MEMORANDUM

Subject: **RZ 15-071:** Applicant, Acadia Homes & Neighborhoods c/o Smith, Gambrell & Russell, LLP on behalf of CR V Perimeter LLC, seeks permission to rezone property currently zoned Office-Institution (O-I) District to Multi-dwelling Residential-85 (RM-85) District to allow for construction of an 81-unit, fee simple townhome development. The subject property is located at 54 Perimeter Center East, Dunwoody, GA 30346. The tax parcel is 18-347-01-008.

TOWNSEND AT PERIMETER
 A MASTER PLANNED RESIDENTIAL COMMUNITY
 54 PERIMETER CENTER EAST
 FOR
ACADIA HOMES & NEIGHBORHOODS
 2100 POWERS FERRY ROAD
 SUITE 300
 ATLANTA, GEORGIA 30339
 PHONE: 770-319-7424

CONCEPTUAL SITE PLAN

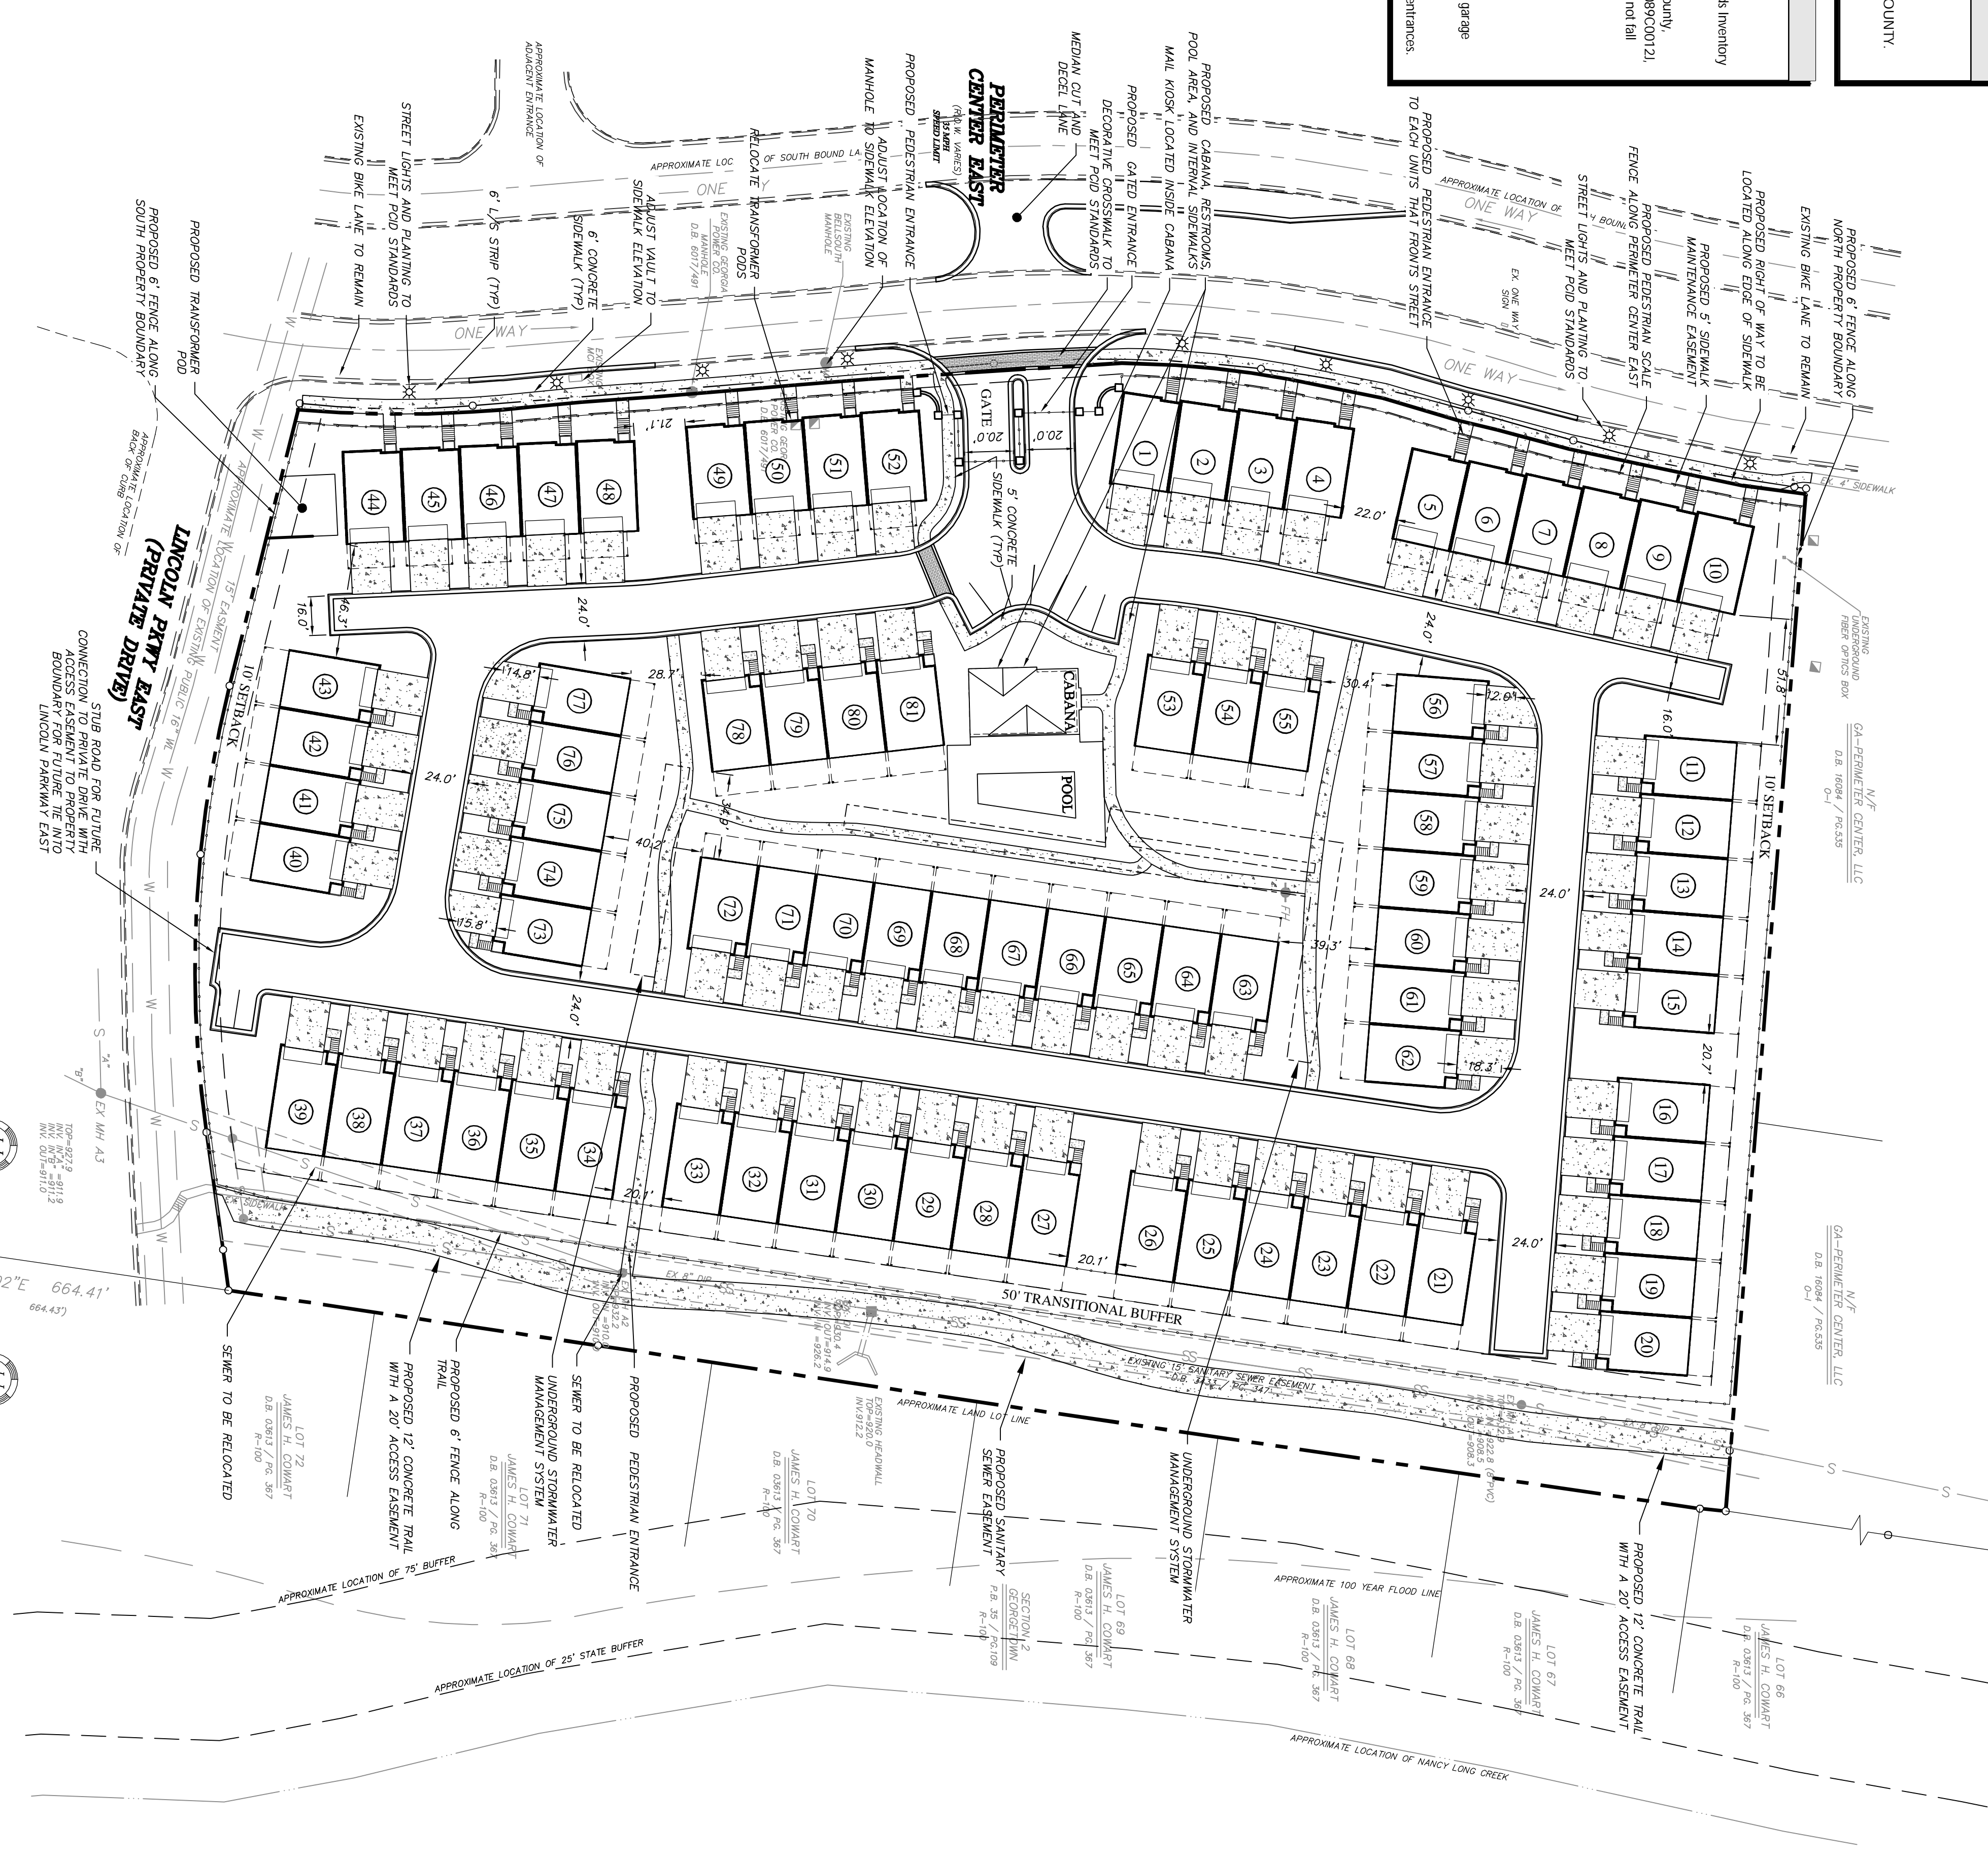
According to the conceptual site plan dated April 7, 2015, the applicant proposes to construct fifteen multi-dwelling buildings ranging from three dwelling units per building to seven dwelling units per building. Each dwelling unit is approximately 24 feet wide. A common area building and pool are included in the site plan. As part of the City’s vision for a connected trail system, the applicant is proposing to dedicate and construct a twelve foot concrete path that runs parallel to the eastern lot line. This path would eventually become part of the trail that extends from Brook Run Park thru the Georgetown area. Staff is recommending that an internal sidewalk be provided on one side of the internal road. This would run along the road. The plans do not currently reflect this feature.

Parking consists of four spaces for each unit, two in a driveway and two in a garage. Guest parking is also provided to meet code. This development is not within a comprehensive plan area designated for Senior Housing and no elevator is proposed with these units.

In particular, the request for the reduction in the number of access points is supported by staff because the one access point is in compliance with Fire Code; the applicant is accommodating for a second entrance via a drive isle and access easement adjacent to the private road, Lincoln Parkway; the threshold to require a second entrance is prompted by the development of more than 75 units, and the proposed development is on the low end of that threshold; and the configuration of the single drive and proposed future drive is preferable from a safety and access management perspective to the addition of two curb cuts along Perimeter Center East that would be too close and would not offer any additional transportation benefit. Staff does not support the request to reduce the driveway depth.

1. Development shall be in substantial compliance with Exhibits A, B, and C.
2. Access easement for access to Lincoln Parkway shall be recorded prior to issuance of land development permit.
3. Street furniture shall be in compliance with PCIDs standards and shall include a recycling receptacle. The recycling receptacle shall be maintained by the property owner if DeKalb County Sanitation does not service recycling receptacles.
4. Identical elevations shall be separated by a minimum of three other units.
5. Asphalt shingle roofing shall be a minimum three-dimensional Architectural type.

TREE REPLACEMENT PLAN

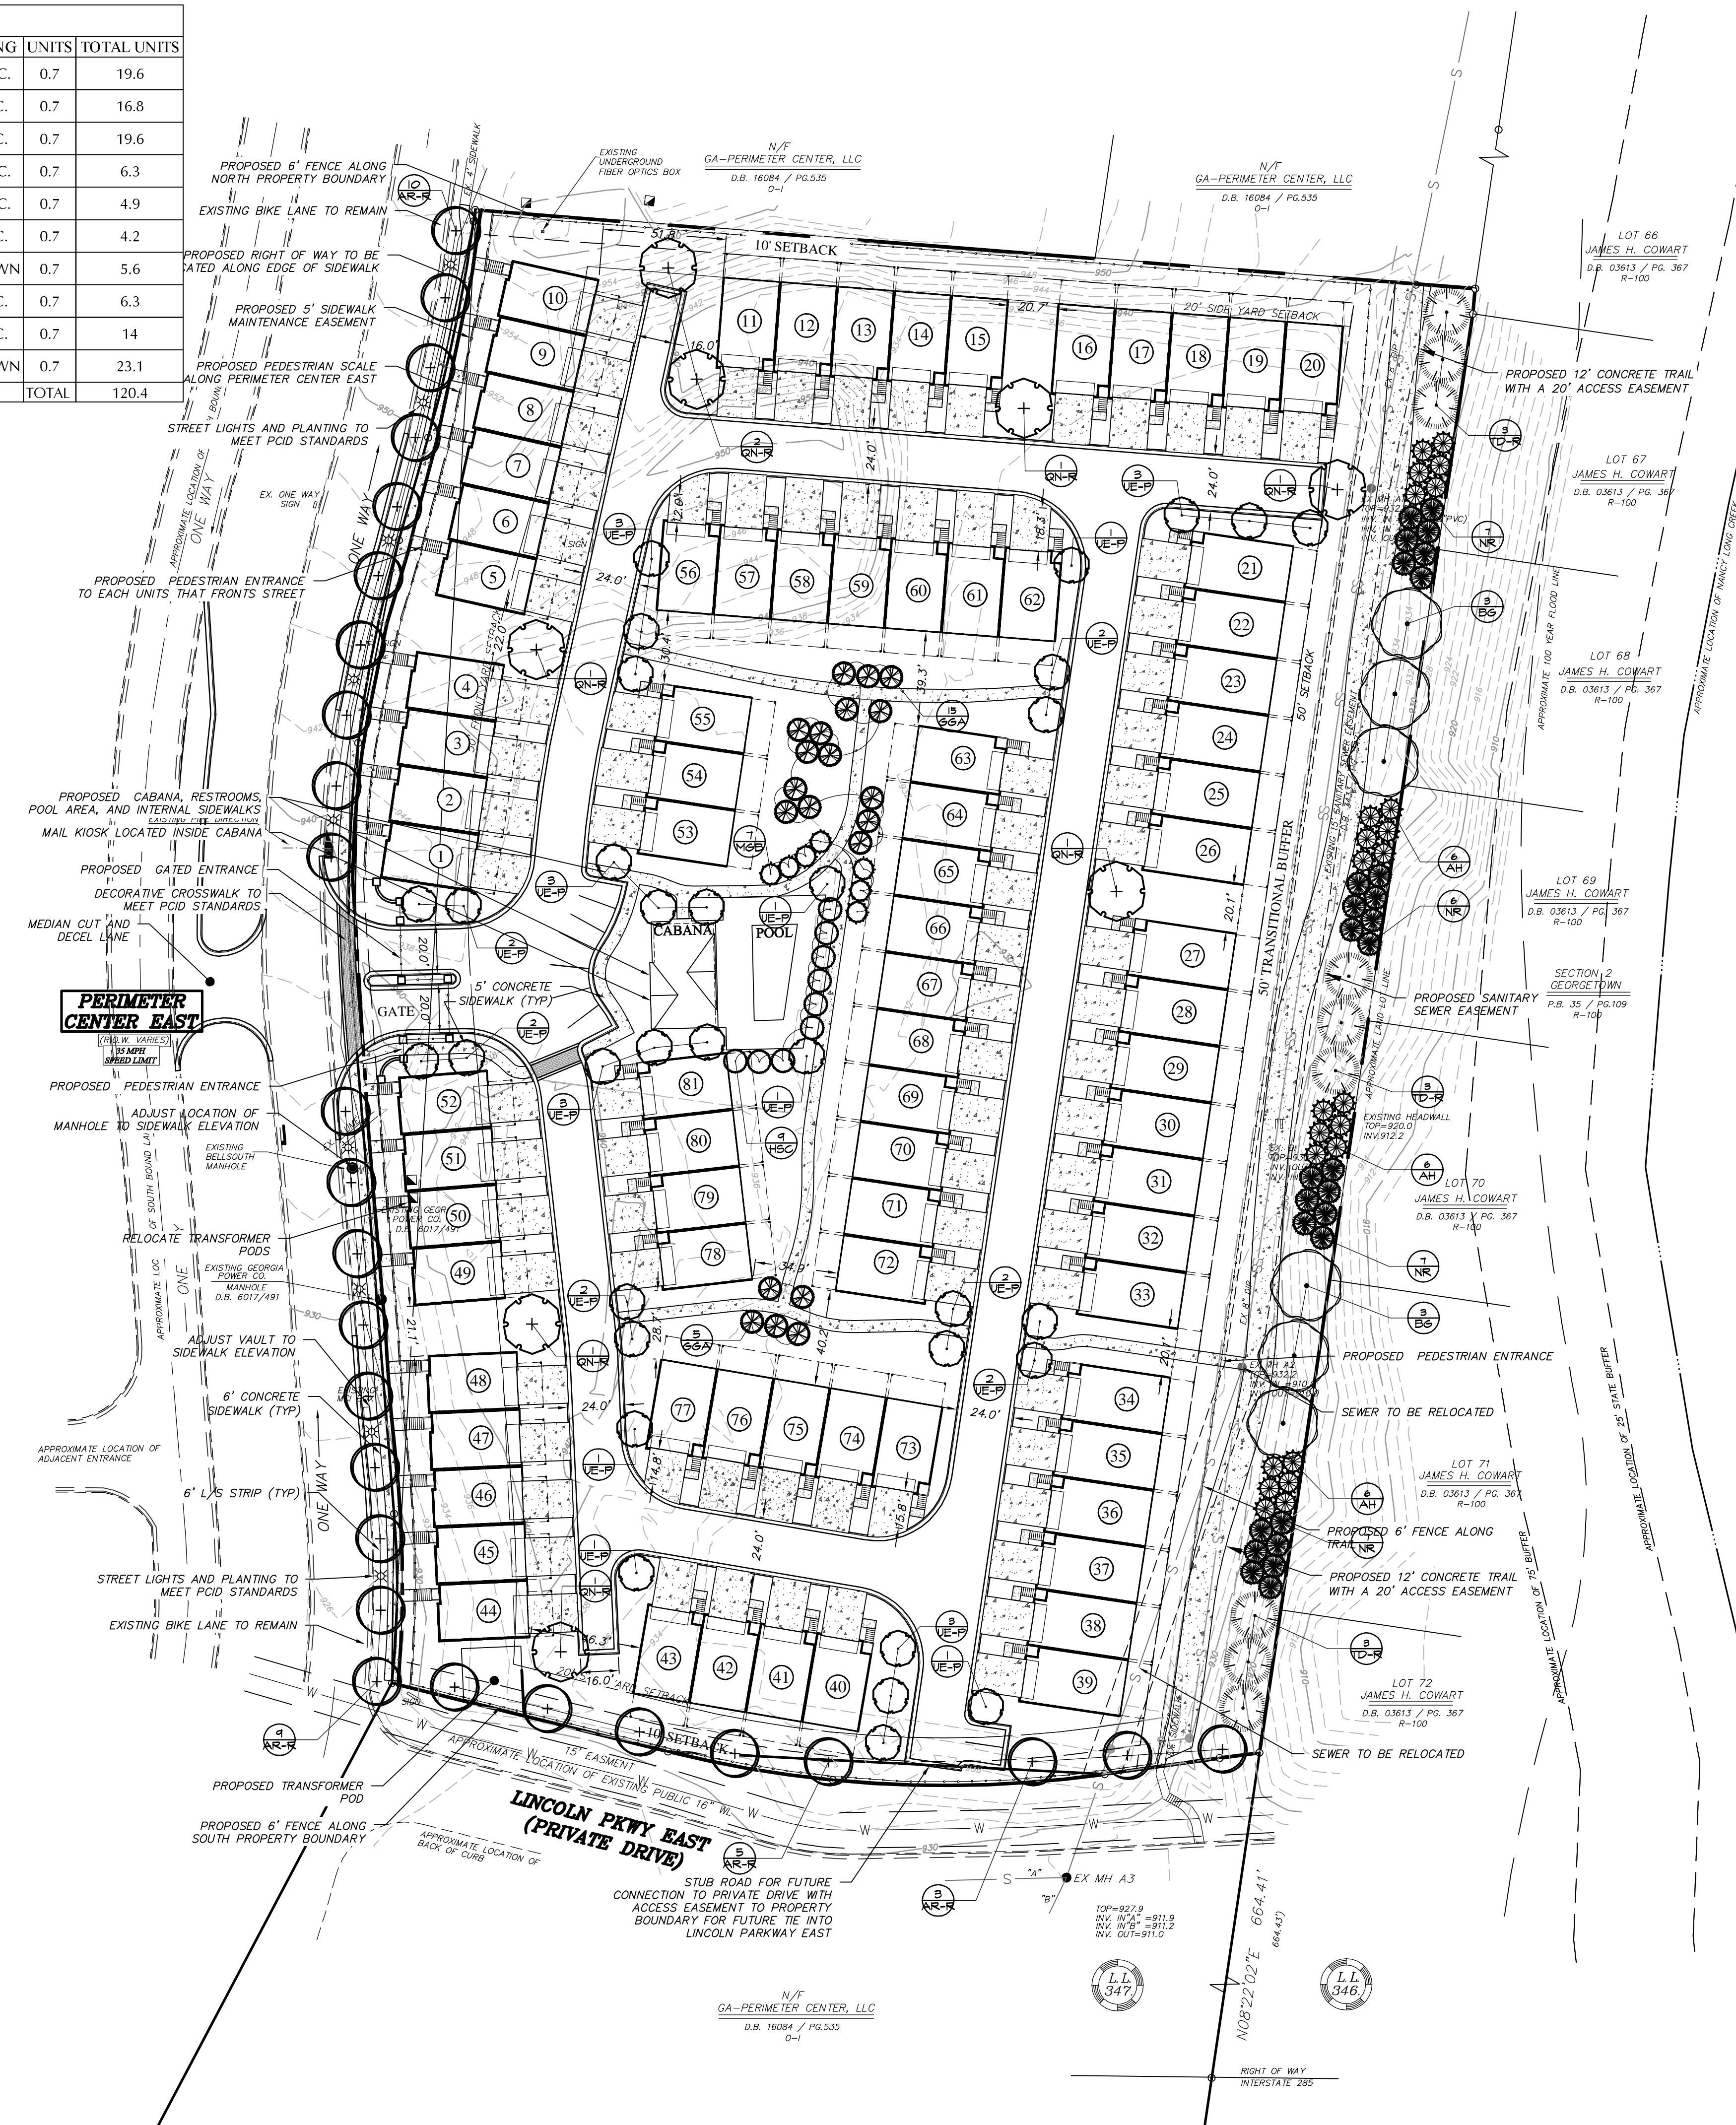
Staff recommends the applicant retain as many mature trees as possible along both sides of the path to preserve the natural corridor; however, a tree preservation plan has not been submitted to determine the impact on the existing canopy. A tree preservation plan identifies the new trees proposed, but it does not account for the potential recompense for removing specimen trees; therefore, the required replacement density may be greater than calculated on the plan.
